PanoVu Camera Firmware Version: V5.5.90

Release Note

(2021-03-29)

Firmware Basic Information	Firmware Version:	V5.5.90_210302
	SDK Version:	V6.1.6.40build210204
	4200	V3.4.2.1
	ONVIF	1912
	NVR	DS-9632NI-I8
	Player	VLC3.0.3, realplayer16.07.0, QuickTime7.6.8

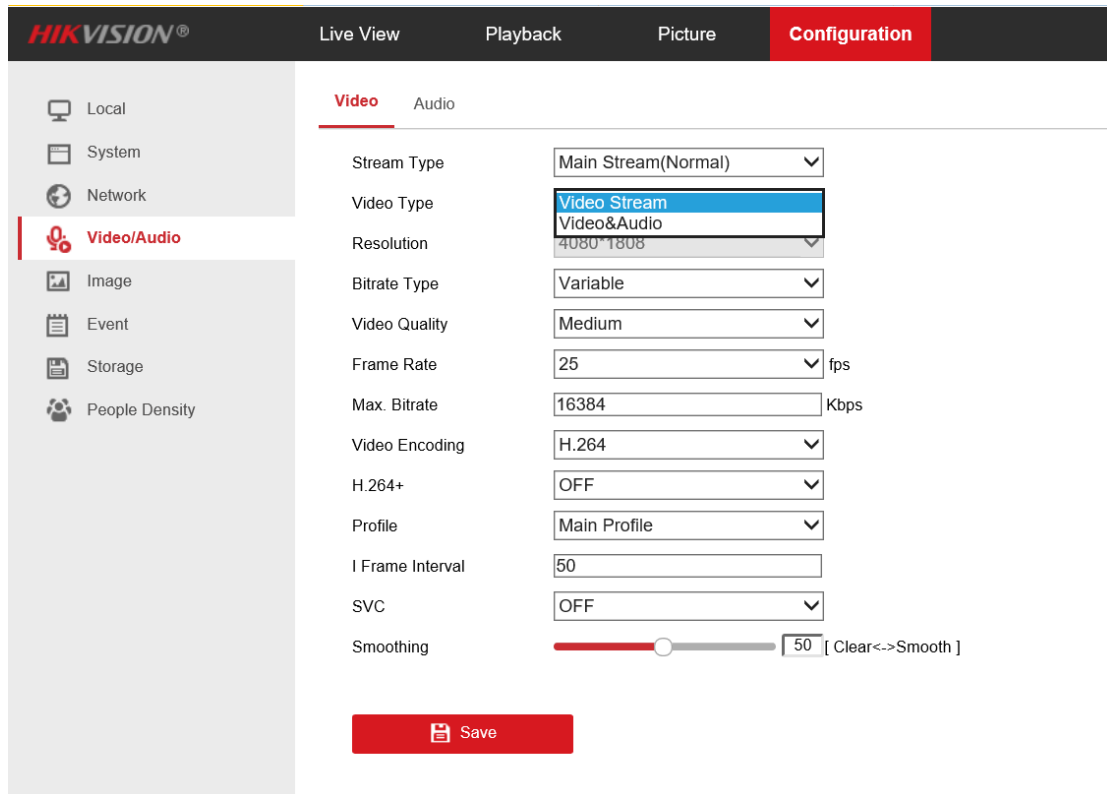
- 6984 model newly supports people density detection under panorama mode of 8 MP resolution (VCA resource switchable under panorama mode). This function takes effect after restart.

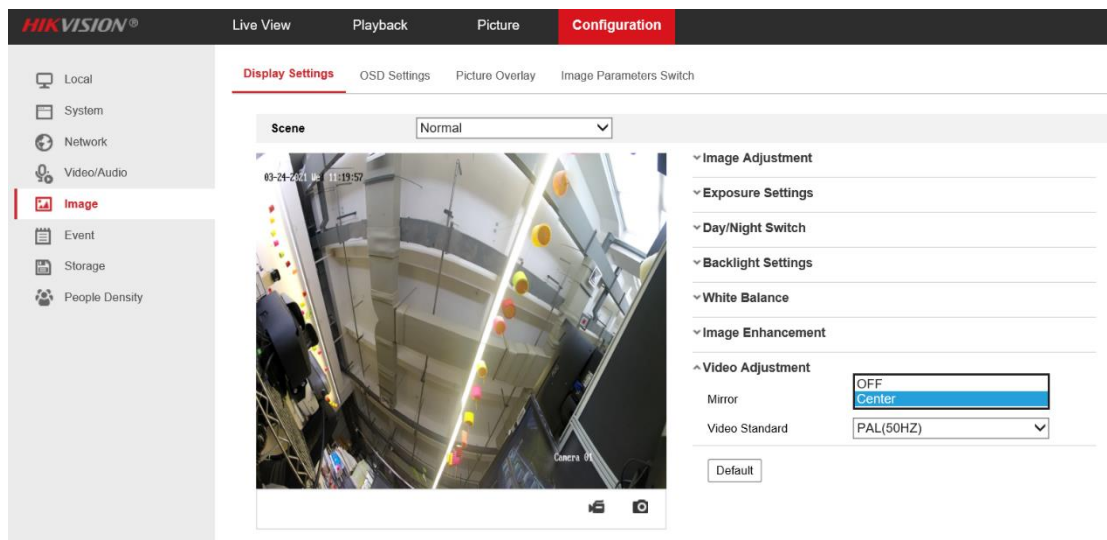
- 6984 model supports main stream and sub-stream under 8 MP resolution with people density VCA resource.

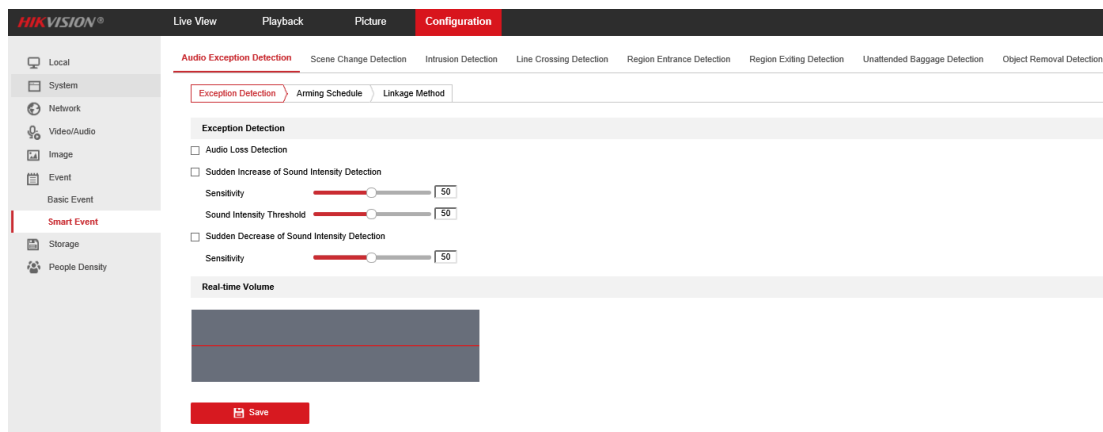
- Mirror function is supported by 6924/6944 model and 6984 model with 8 MP resolution and people density VCA resource.

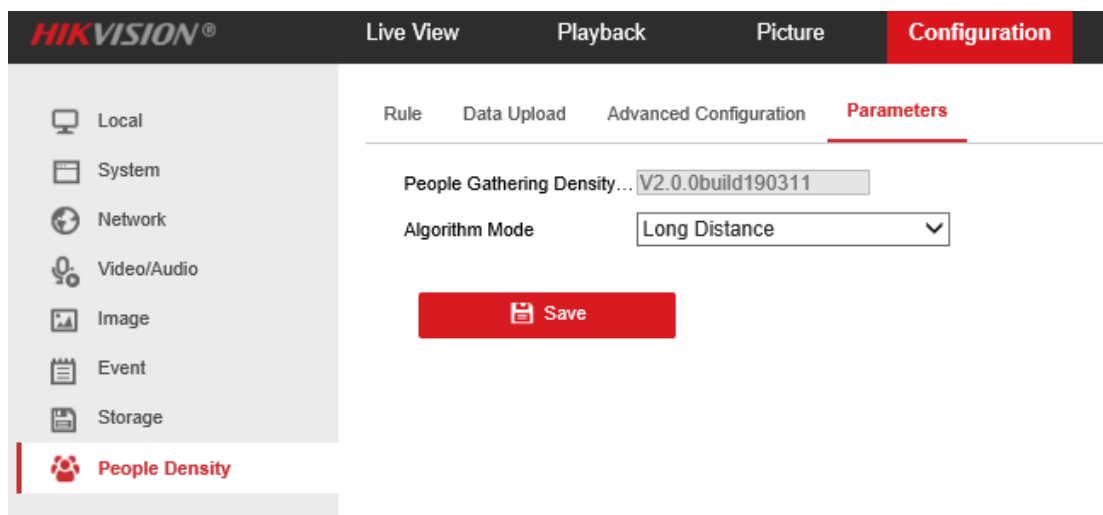
- Algorithm mode is shown on the people density page.
